ADDENDUM #1

To: Prospective Bidders
From: Porter Co. Dept. of Development & Storm Water Management
Date: November 8, 2024
Subject: North Stimson Drain Tile Reconstruction

NORTH STIMSON DRAIN
DRAIN TILE RECONSTRUCTION
PORTER COUNTY, IN
FINAL PLANS

Project Number: 238102157
 File Name: 238102158_ESC_N Stimson Drain.dwg
 JTC RAS JTC 24.02.12
 Dwn. Chkd. Dsgn. YY.MM.DD
 Drawing No.
 Revision Sheet
 2 14 of 26

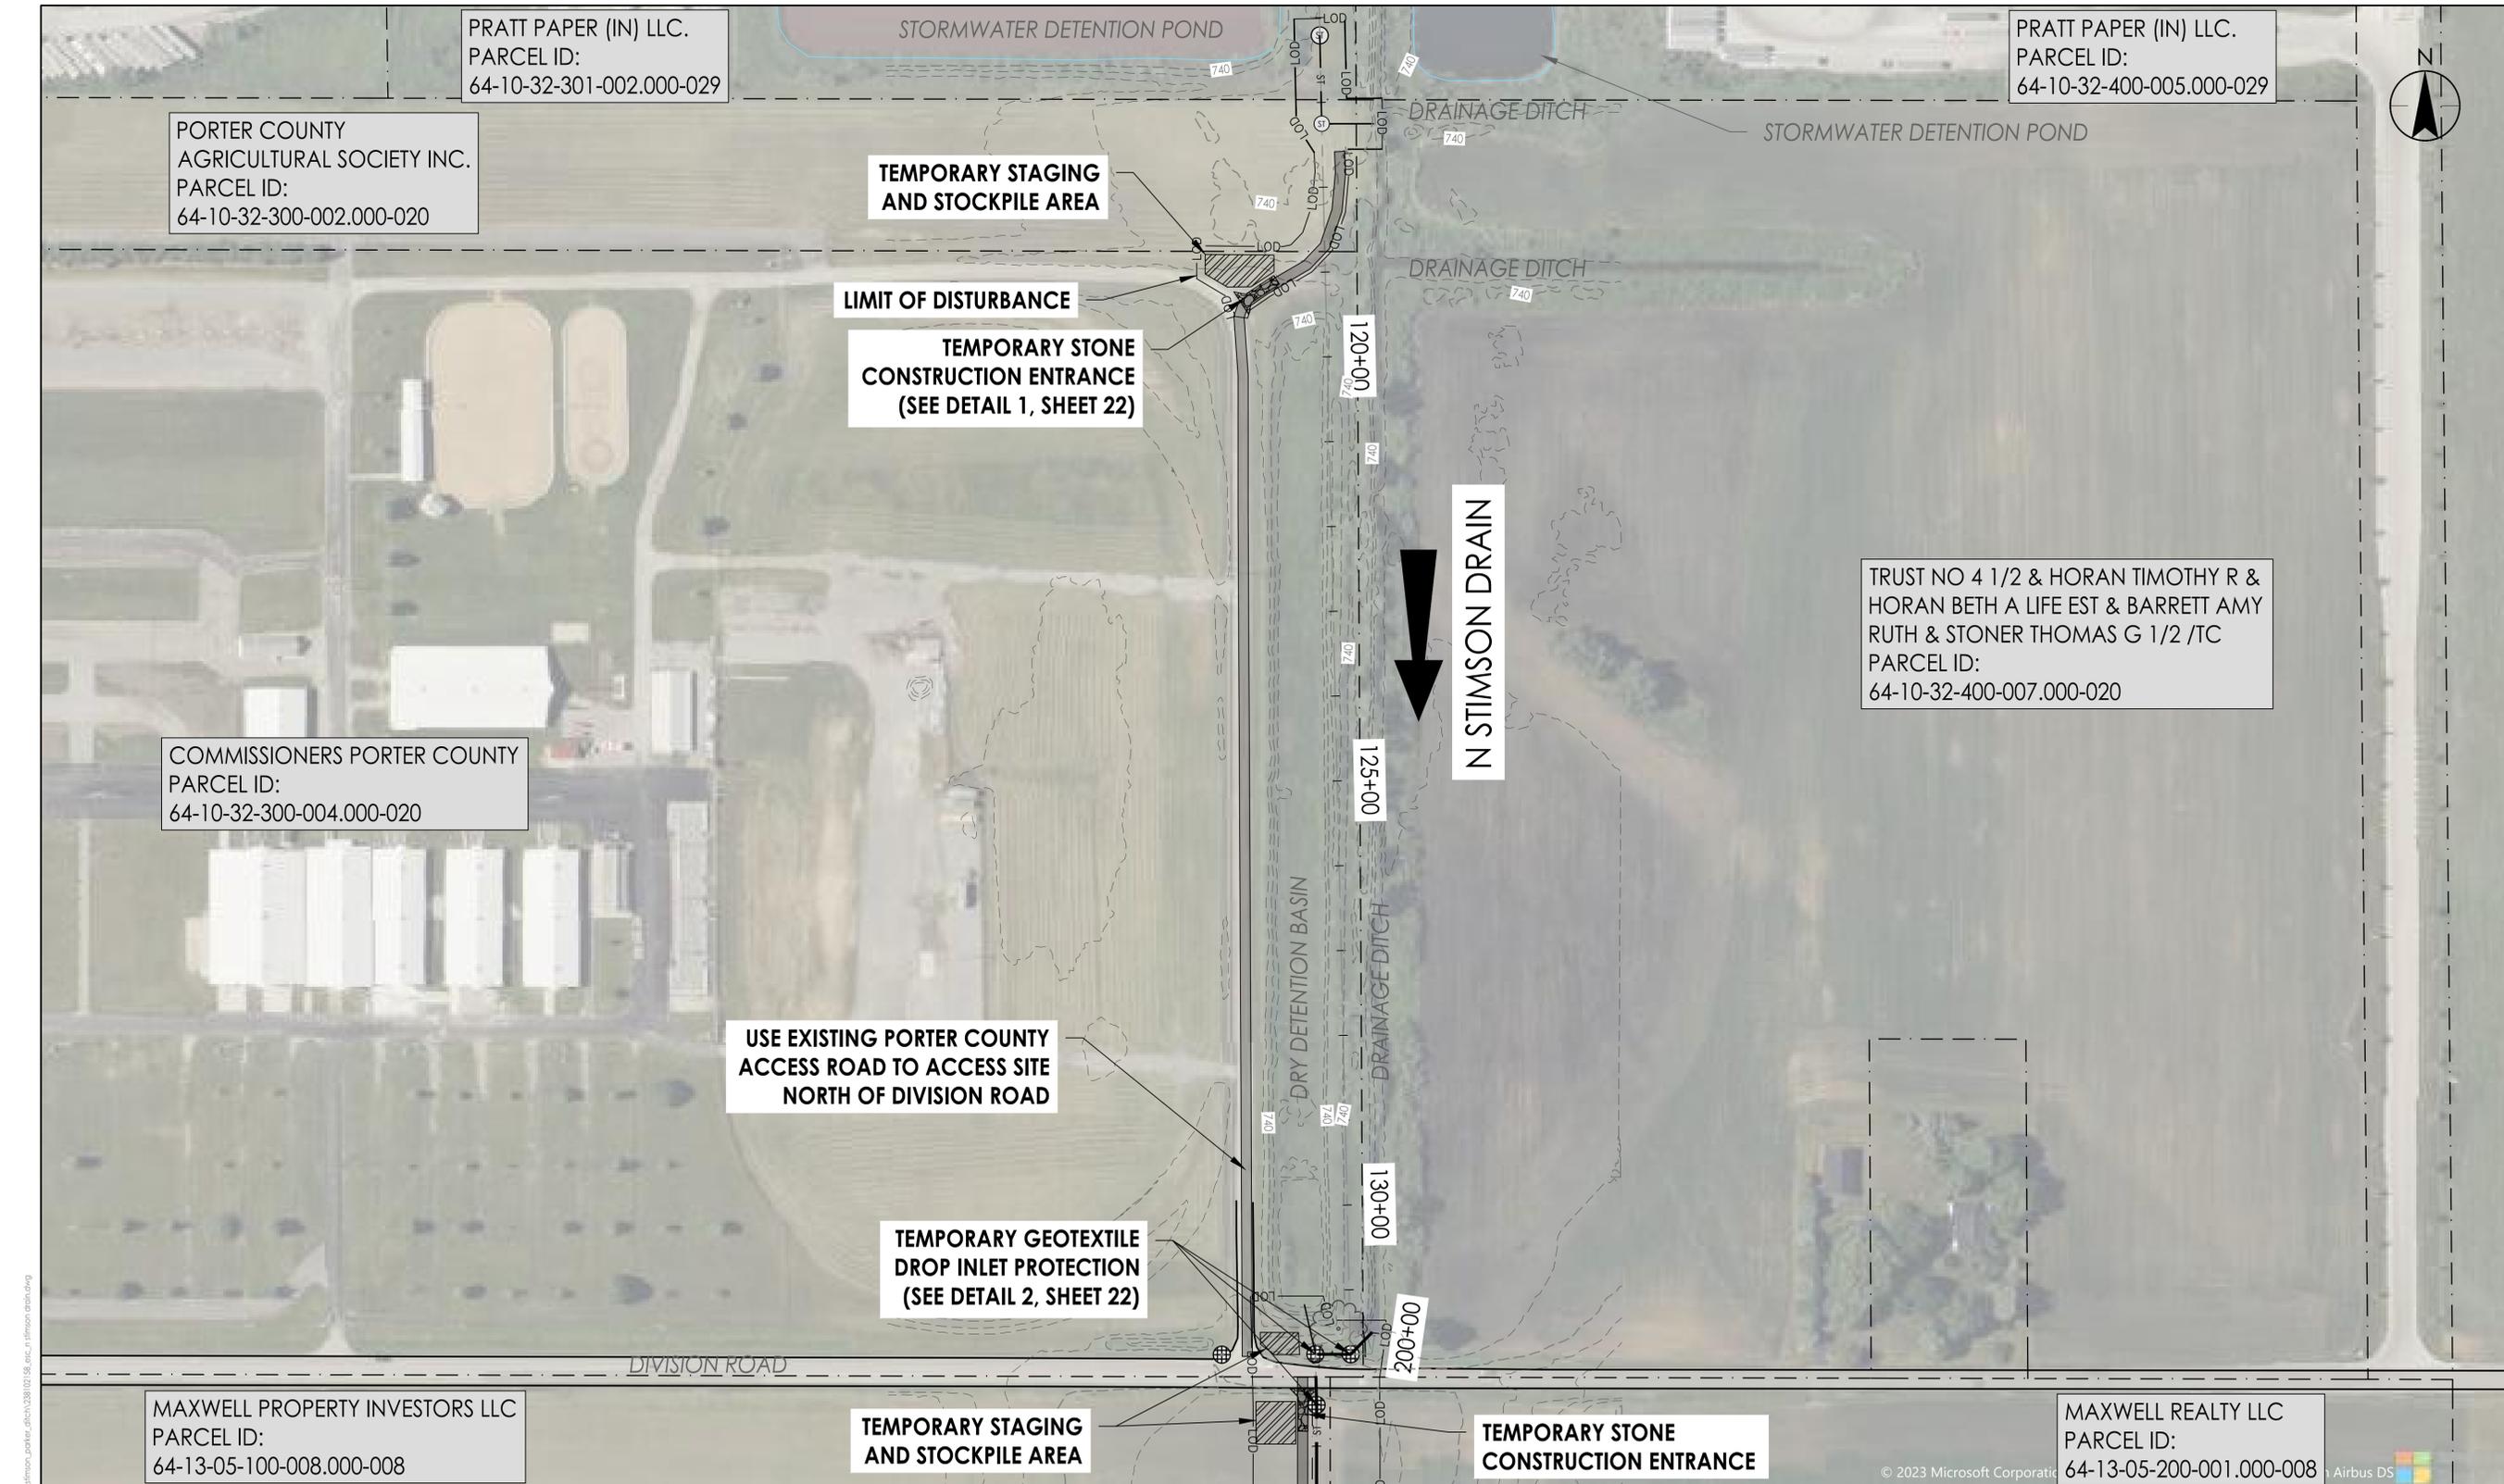
The construction plans have been revised on Sheets 14, 15, and 16 to correct the scale bar to 1" = 100'.

6. Q: Bid Item #6 indicates 600 LF of silt fence, there are only two locations of silt fence (approx. 300' total) shown on sheet 16 of 26, is there additional silt fence located elsewhere? Will the quantity on the bid form be revised?
A: The silt fence quantity shown in the Basis of Bid Form is correct. The scale was off on sheets 14, 15, and 16, which has been corrected.

1. A: The silt fence quantity shown in the Basis of Bid Form is correct. The scale was off on sheets 14, 15, and 16, which has been corrected.
